Accessibility Survey

City of Downey Songfest Drive - Brookpark Road to Klinedale Avenue

Date of Inspection
6/19/2017

Prepared By
Disability Access Consultants
(800) 743-7067

Change in Level East of Brookpark Road @ 33.949765865362, -118.100392073393

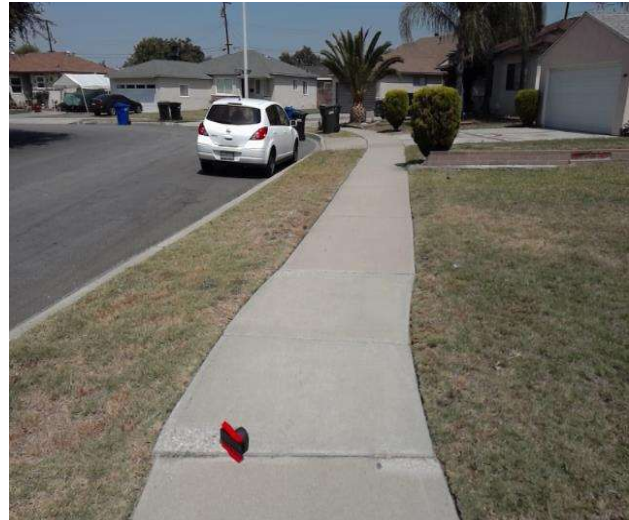
There is a change in elevation greater than recommended value.

On-Site Finding 0.50 inches

Ensure that the change in elevation is within the recommended value.

Recommendation Up to 0.25 inches

Sidewalk South of Telegraph Road @ 33.950546824918, -118.099997788668

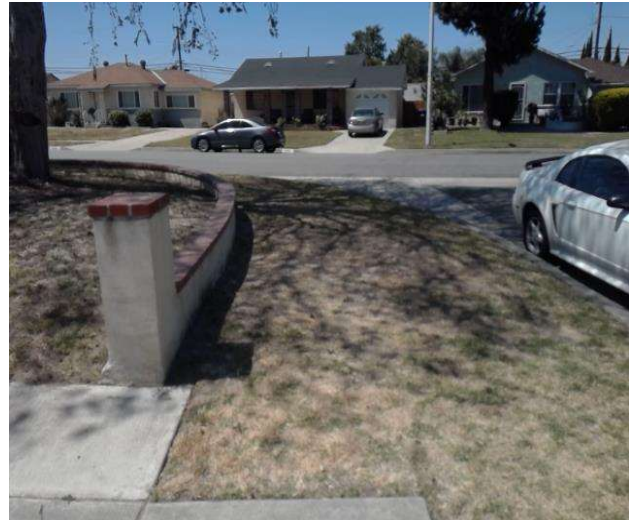
Section of sidewalk is missing and consists of dirt, grass or gravel.

On-Site Finding 33.00 feet

Provide a compliant sidewalk for the missing section.
